**Subject: MHI's Amended Response to US-APWR DCD RAI No. 740-5719  
Revision 2 (SRP 06.02.02)**

Amended Response to Request for Additional Information  
No. 740-5719 Revision 2

**RAI NO.:** NO. 740-5719 REVISION 2  
**SRP SECTION:** 06.02.02 – Containment Heat Removal System  
**APPLICATION SECTION:** 6.2  
**DATE OF RAI ISSUE:** 4/26/2011

**QUESTION NO.: 06.02.02-64**

Figure b-1 Film Condensation at Structure Surface

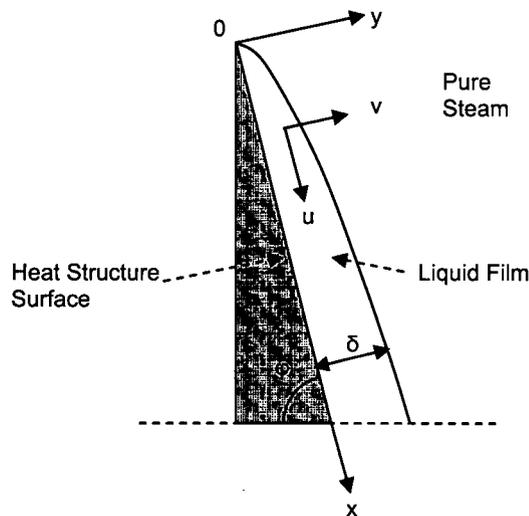
- o Condensate water on containment surfaces – Equation listed for film condensation correlation used to calculate film thickness could not be readily verified (reference in Japanese) and was not found in standard textbooks on heat and mass transfer. Appropriate reference and justification should be provided for the applied methodology and selected input values. Film thickness will be a function of the surface height. Justify estimated vertical surface area and corresponding heights

Condensate film thickness was calculated from Eq. 11 in the holdup volume calculation based on the fluid conditions. The calculation follows the methodology of theoretically solving the Nusselt film heat transfer correlation, which is widely known and is referenced from Reference 4 and 5.

Assume constant condensation and liquid flow on structure surfaces (Figure b-1).

By Eq.11, condensation liquid thickness on the surface of the heat structure is predicted. The height used for this calculation was 40 meters (about 130 feet), and the resulting condensation film thickness (based on 40 meters height) was applied to all surfaces. The vertical portion of containment from second floor level (EL 25'-3") is about 129 feet. If the vertical height ( $x$ ) increases, the liquid film thickness also increases as shown in Eq. 11. However, the liquid thickness calculated based on a 40 meter height was conservatively applied to all surfaces.

Figure b-2: Sketch of flooding overflow curb

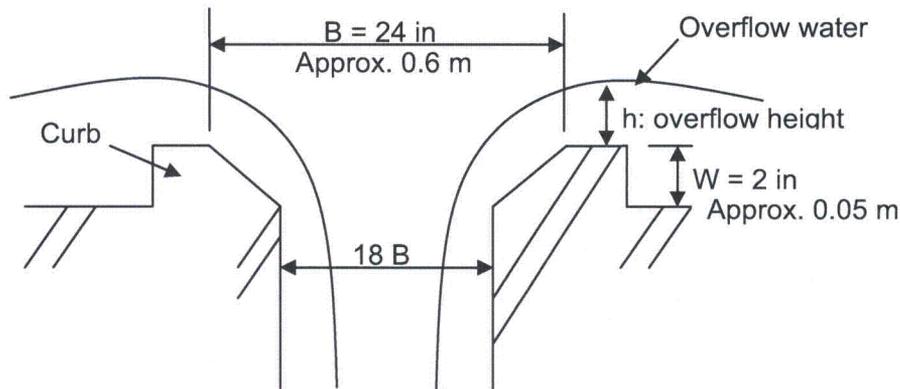
- o Water retained on the floors – Reference and basis was not provided for selected equation (method of evaluation) or input values used to evaluate dynamic retention on containment floor (result was 6" water height above floor). No evaluation was provided for assessing the dynamic retention on upper floors in containment (assumed 2" height above floor). Please provide the reference and basis and for calculating the dynamic water retention heights to include method and input values.

Water depth on the floors is calculated based on the following general expressions.

Width of curb is designed to be approximately 600 mm (approximately 24 inches) as shown in Figure b-2. Width of curb shall be as follows;

$$\begin{aligned} h &= (Q / (C \times B))^{2/3} \\ &= (0.1007 / (2.259 \times 1.9))^{2/3} \text{ m} \\ &= 0.082 \text{ m} \\ &\approx 0.1 \text{ m (Roundup)} \\ &\approx 4 \text{ in} \end{aligned}$$
